# Westside Revised Draft Community Plan and Development Code

# Plan Revisions

**Revised Draft**  
**October 2012**

## Circulation Actions

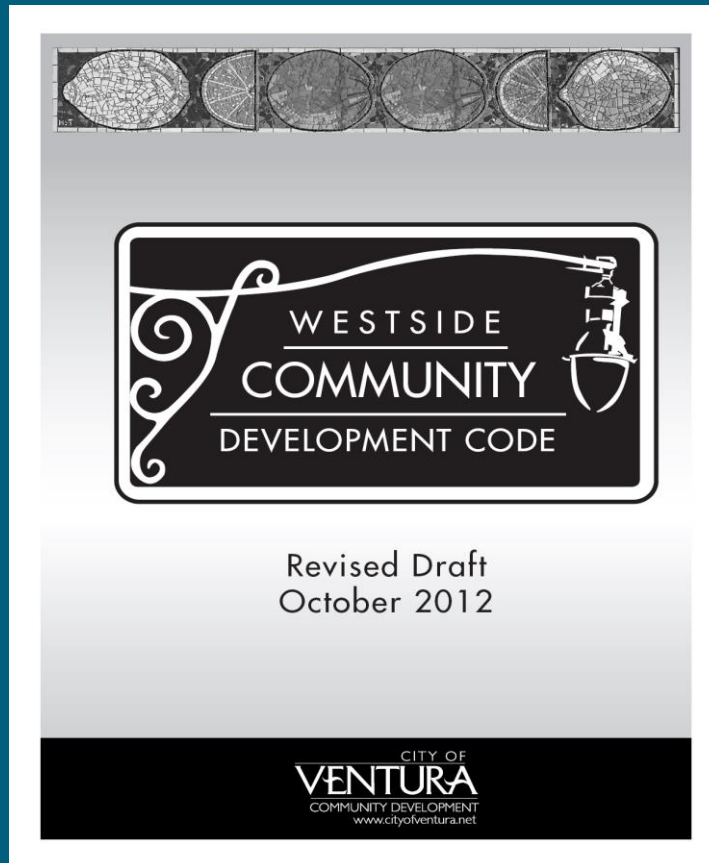
- Removed Stanley Ave. extension to Cedar St. through Selby property.
- Created Actions to emphasize off-site connections to the beach.
- Expanded intention of workplan to stabilize Cedar St. hillsides to include Vince, Carr, El Medio, Lewis and Warner.

## Westside Community Regulating Plan

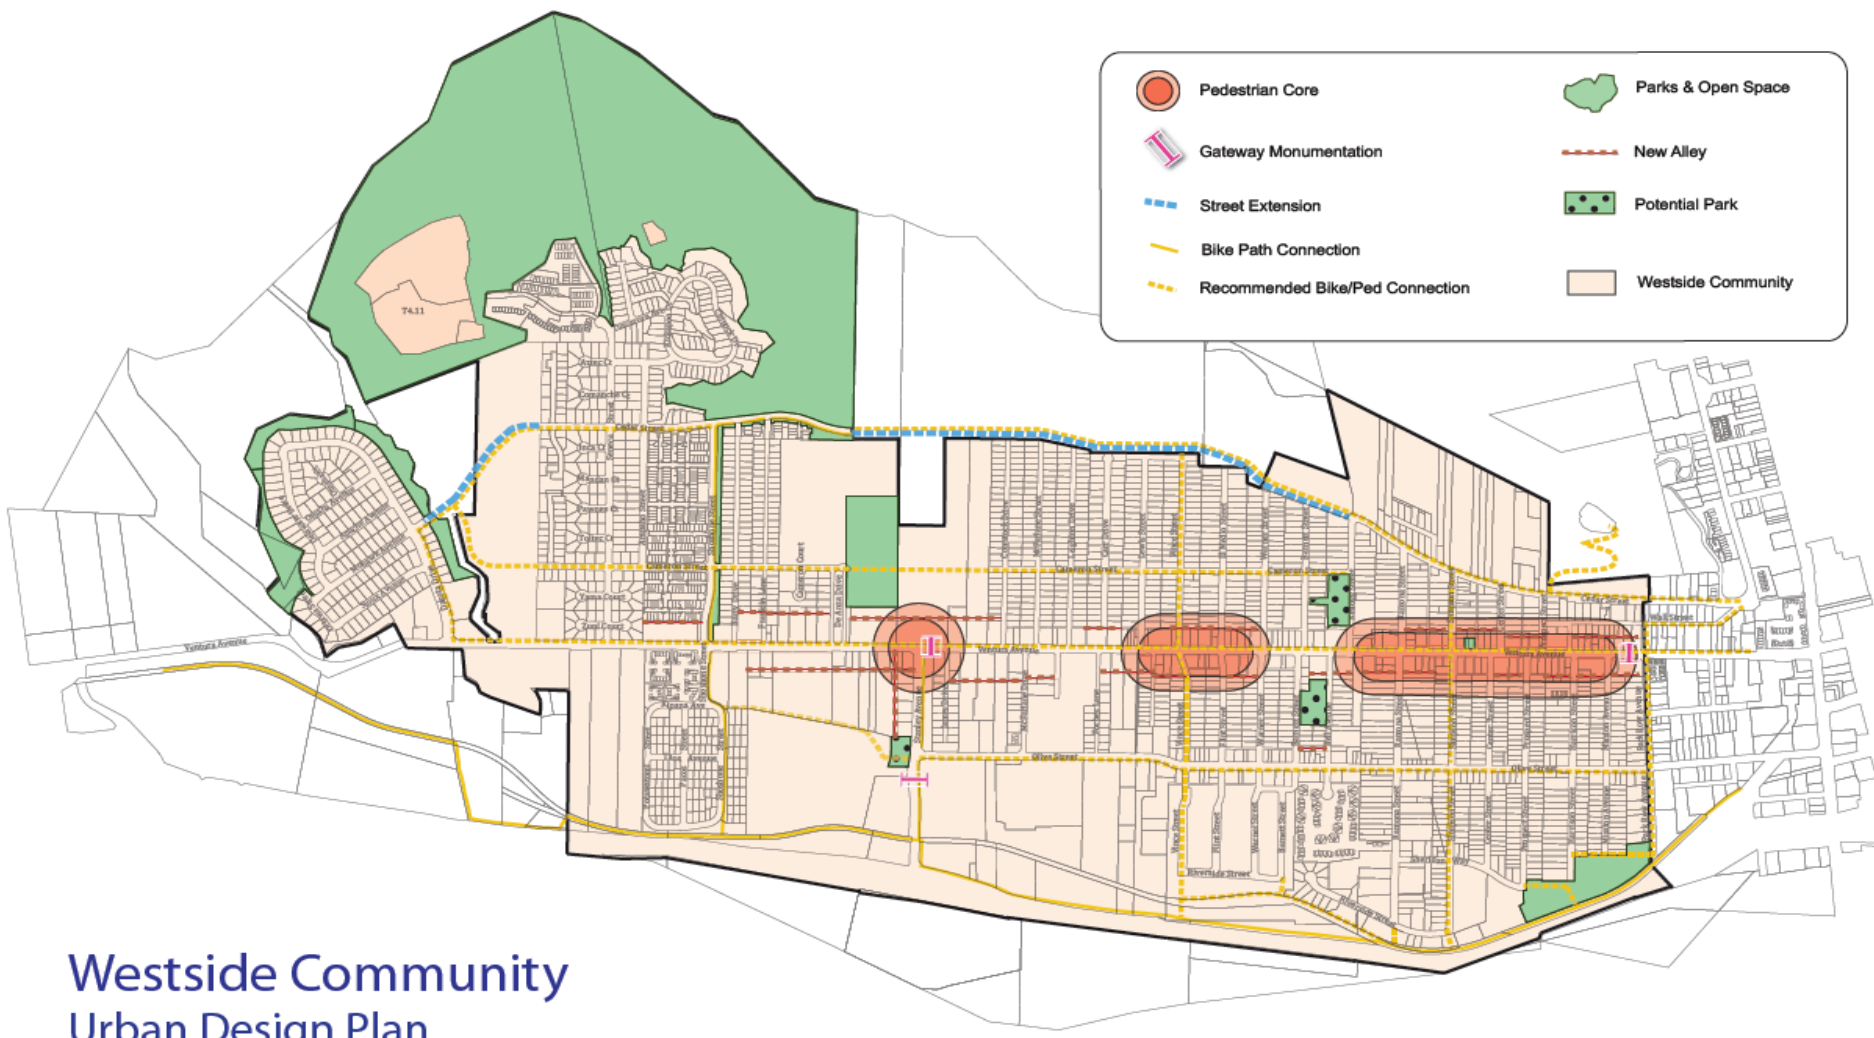
- Edited descriptions of transect zones for clarity.
- Revised Regulating Plan to demonstrate land use policy changes in Community Plan, added potential parks parcels; added circulation plan, modified transect designations where necessary.

**Westside Community**  
Urban Design Plan

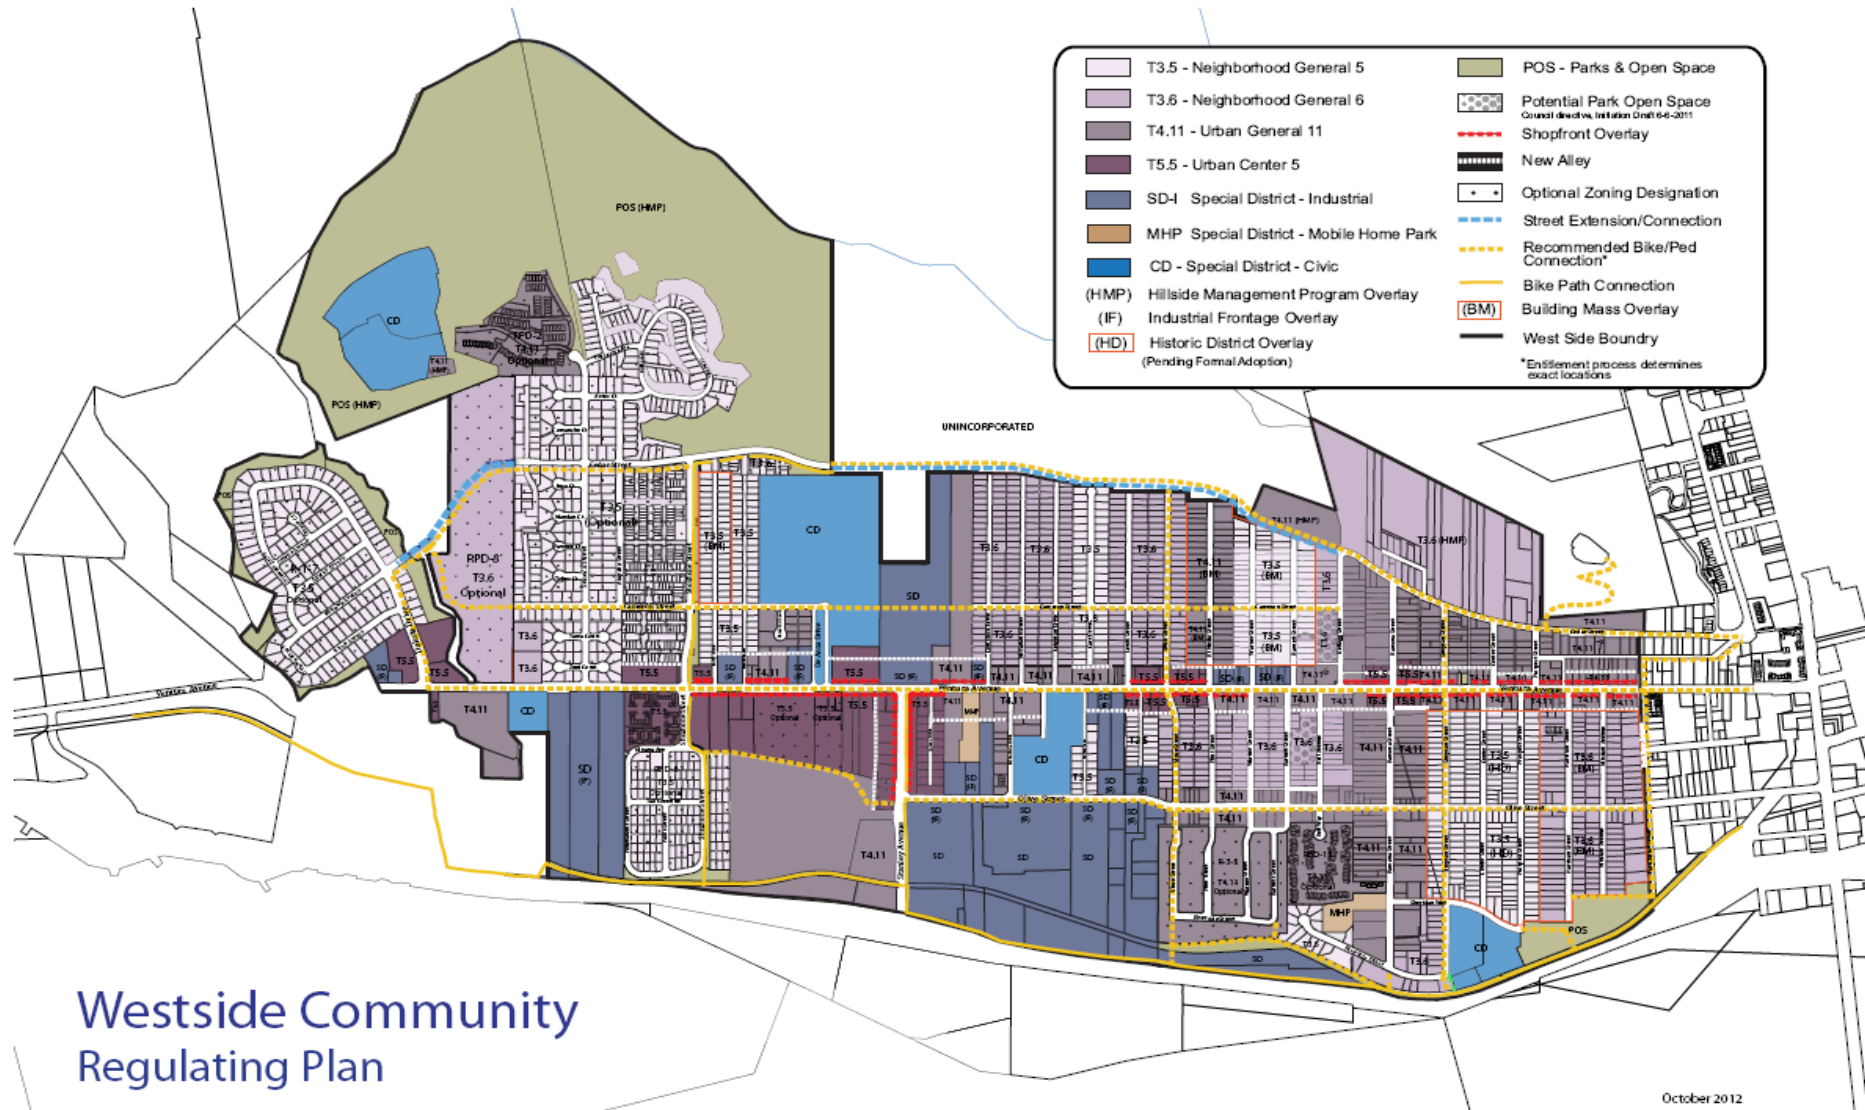
- Removed provision for private incentive to produce green space along Ventura Ave.
- Action 12.6.4 – Pursue opportunity site to develop public park and/or open space.
- Action 12.6.5 – Consider redesignating the General Plan Land Use of the Kellogg St., Bell Way and Stanley Ave. sites.
